Re: Clawe – Comprehensive Permit Plan Changes

Plan Title:	Lot 1 Septic and Well Plan		
Project Name:	Greenwood Street Homes		
Site Address:	0 Washington St (Map 7, Lot 49) - Sherborn, MA		
Owner:	AB Realty Trust	Client:	Robert Murchison
Project No:	J269-19a	Drawn by:	F.A.
Designed by:	DSW/FA	Approved by:	DSW
Scale:	Indicated		
Rev.:	12/18/23	Leaching field, minor grading around SAS	DSW/FA
Date:	12/05/23	General notes, house and driveway, grading, septic inverts & features	DSW/FA
Description:			
By:	A. Murchison

Plan Title: Lot 2 Septic and Well Plan

Plan Title: Lot 3 Septic and Well Plan

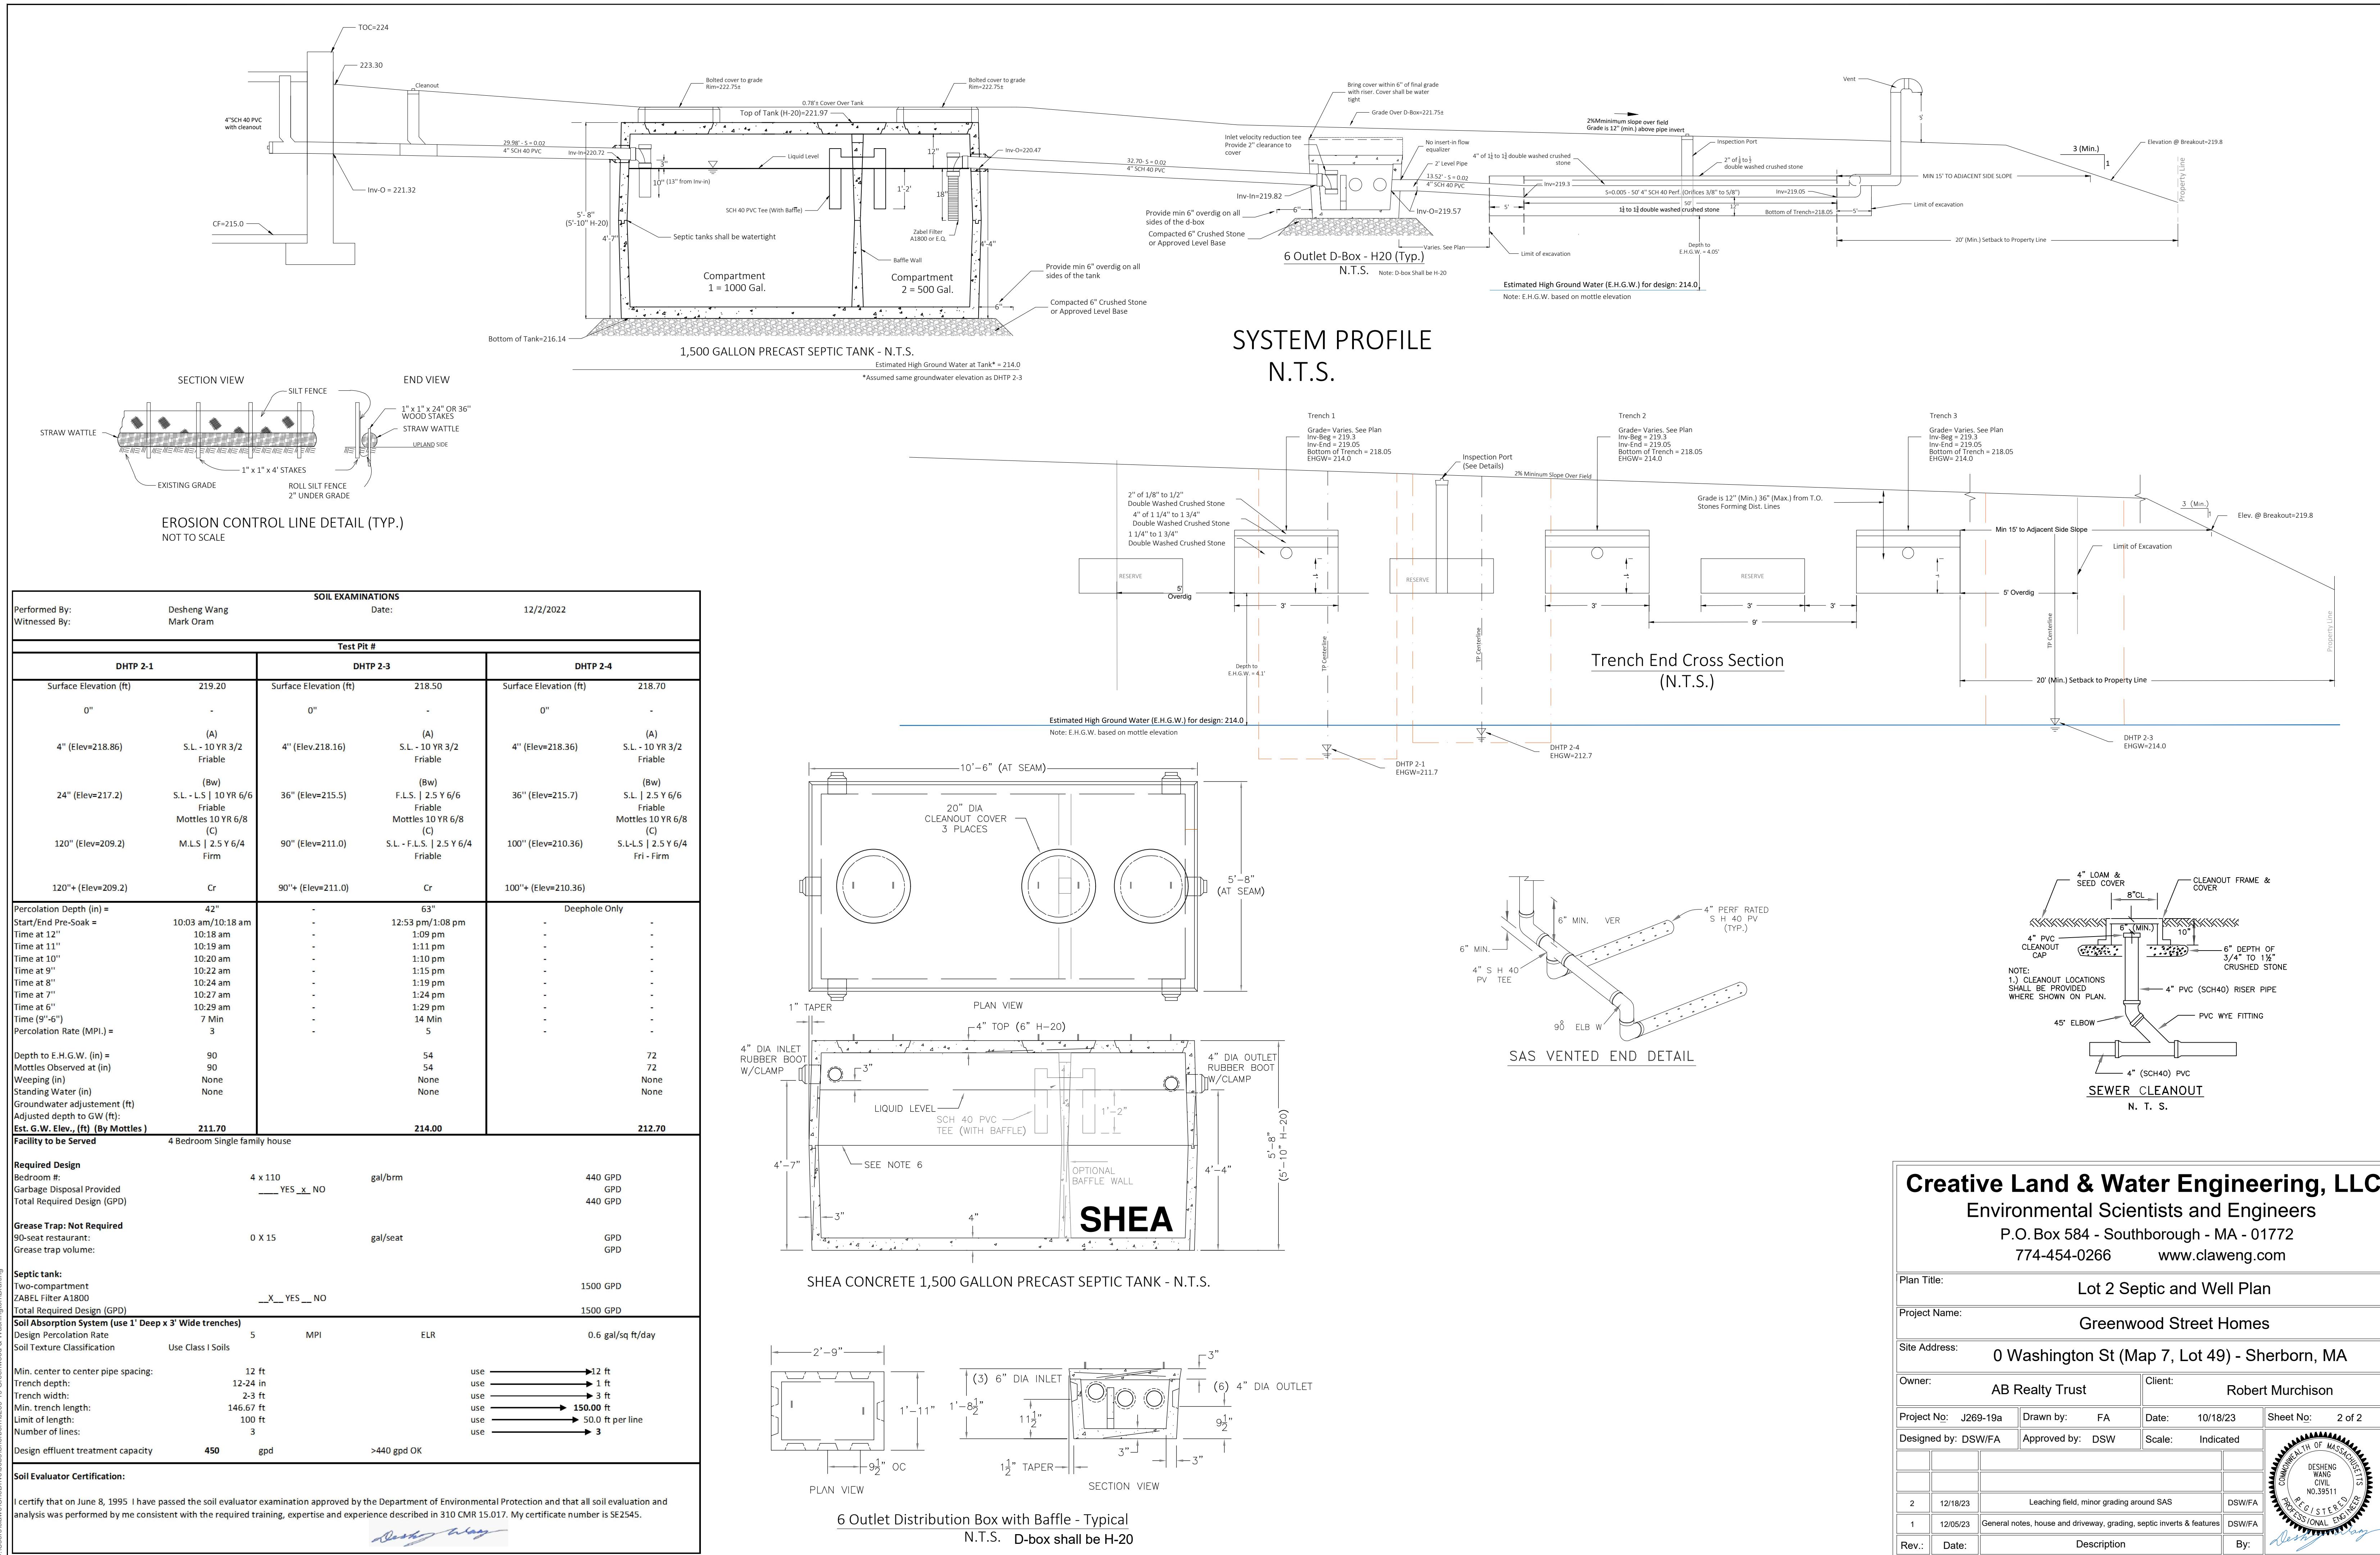
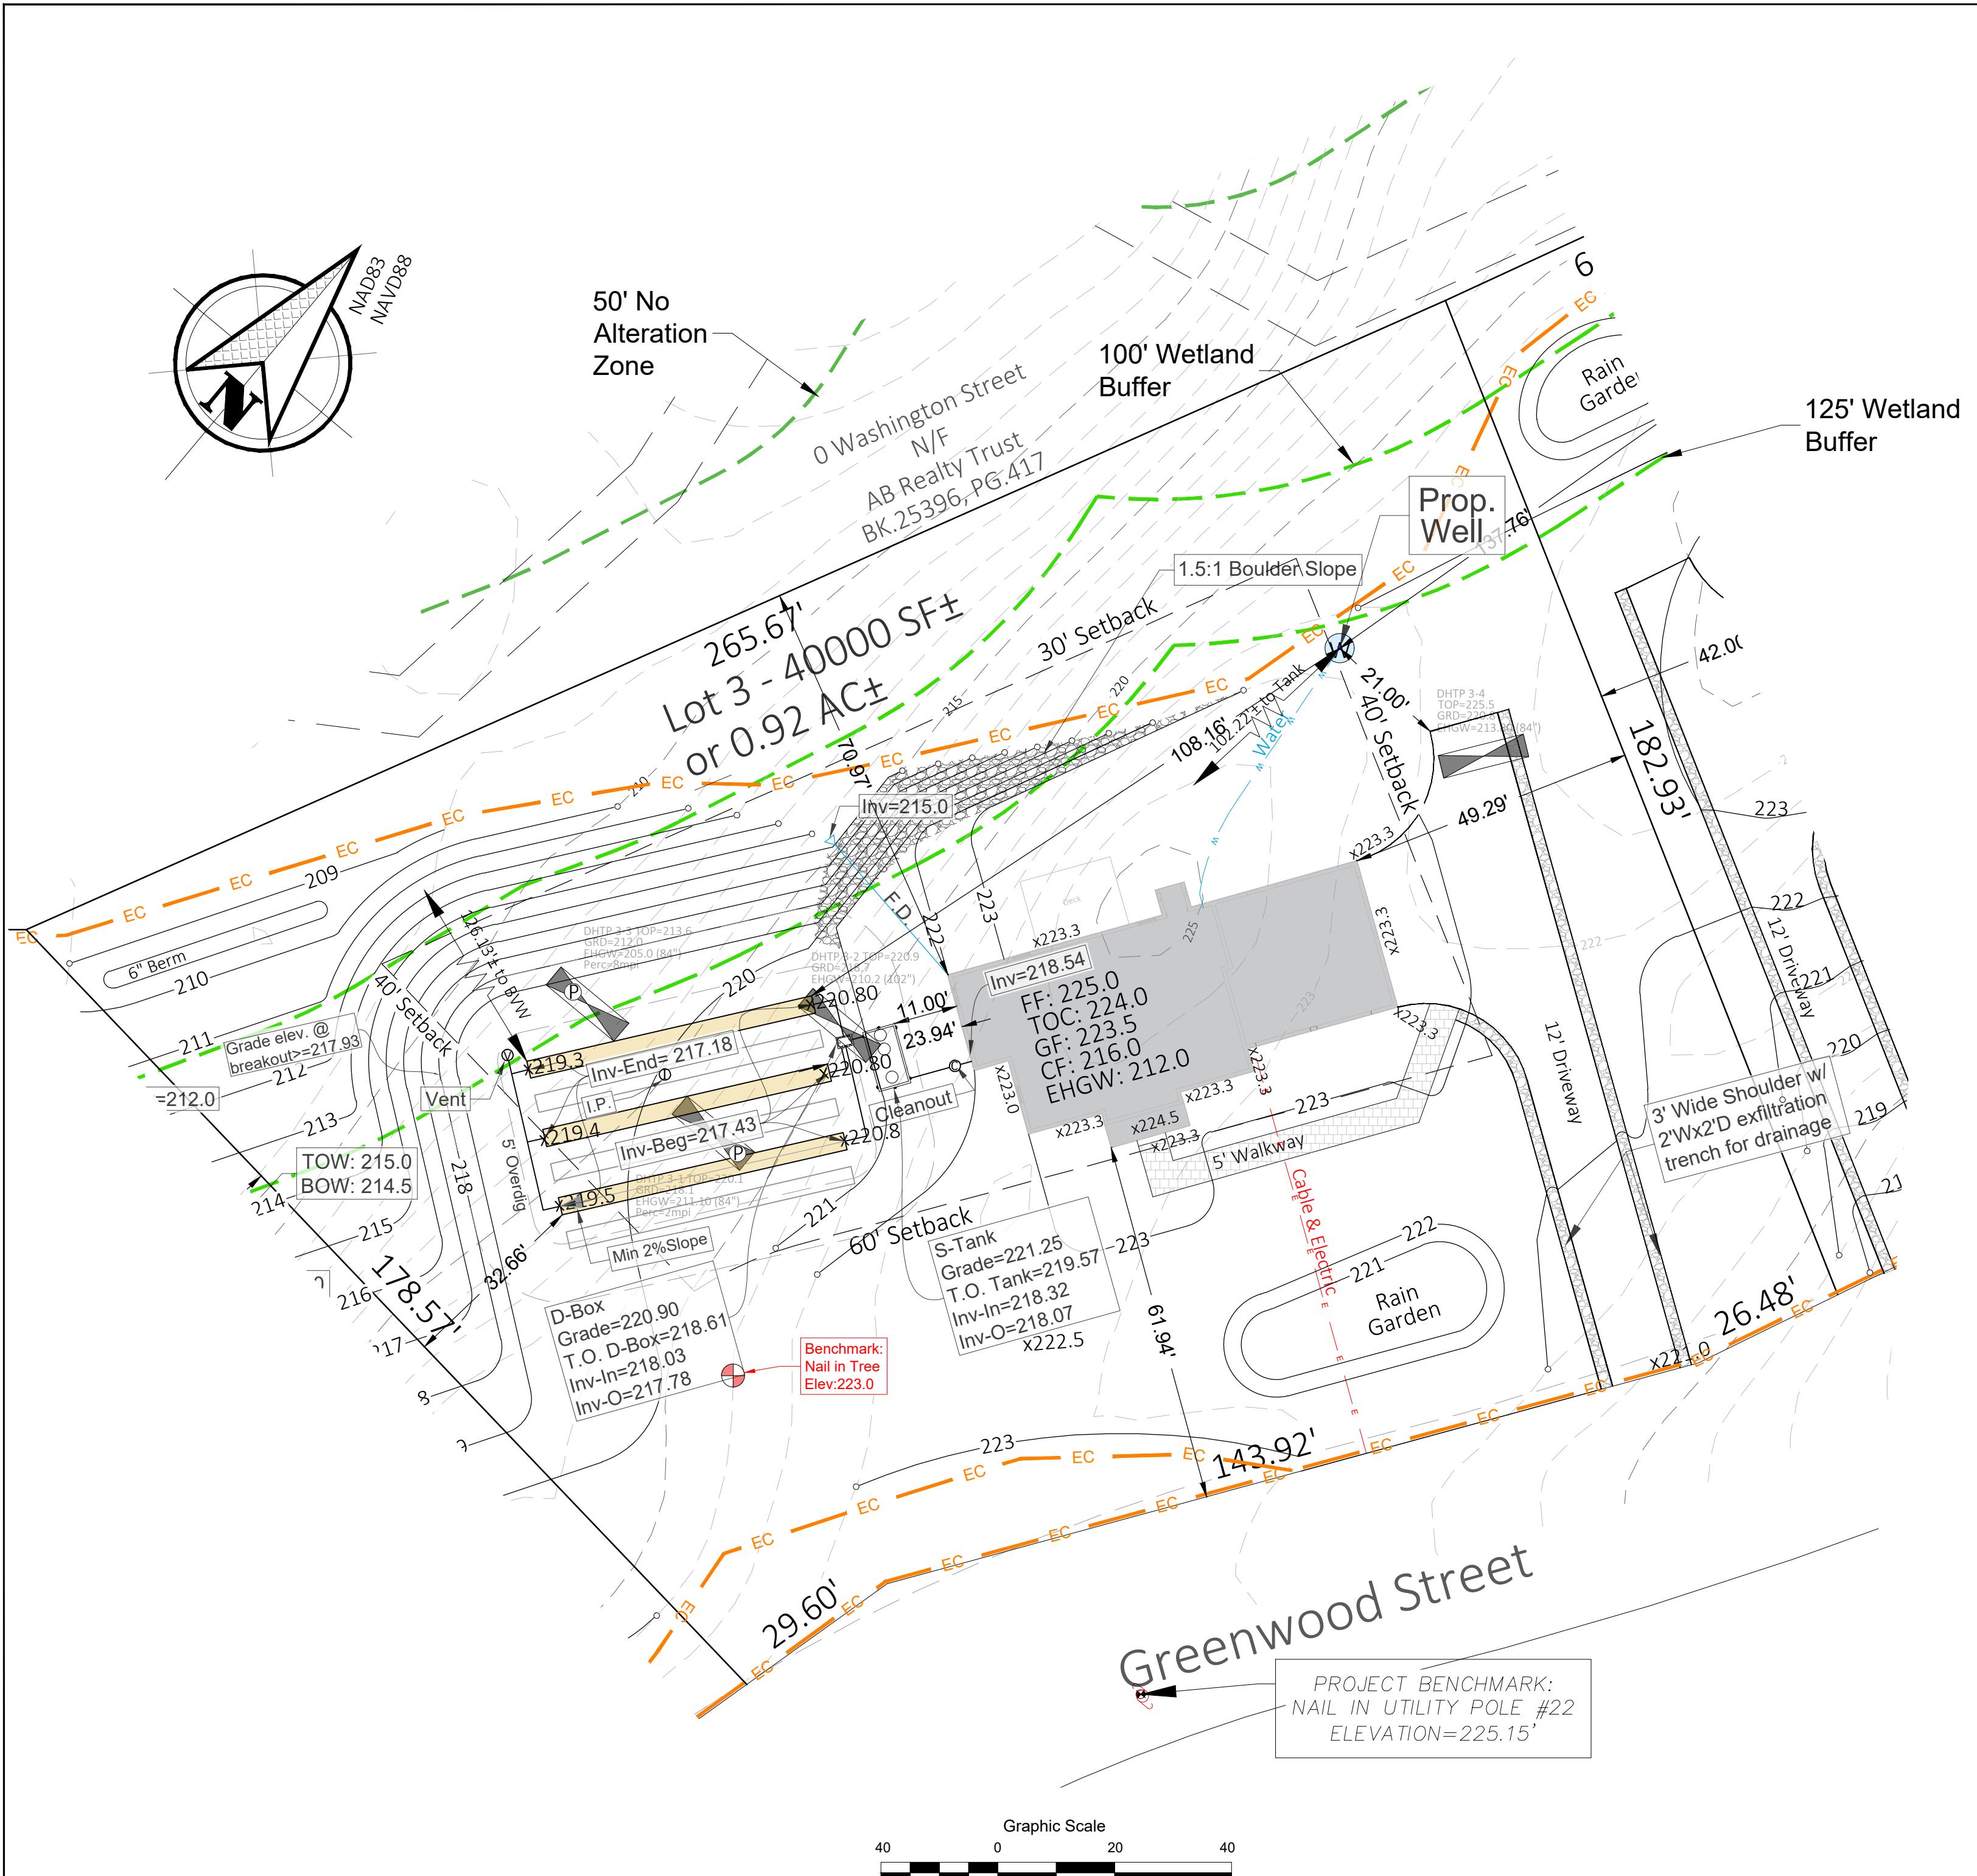
- On Lot 1, the well location shown for the abutting well at 34 Greenwood has been updated to better reflect the "as-built" plan provided by Sherborn BOH. Note the location previously shown was a more conservative estimate based on GIS. All required setbacks have been updated.
- On Lot 1, 2 and 3, the SAS has been resized to reflect the Health Agent's differing characterization of the soil type. Again, all required setbacks have been updated.

2 12/18/23 Leaching field, minor grading around SAS DSW/FA
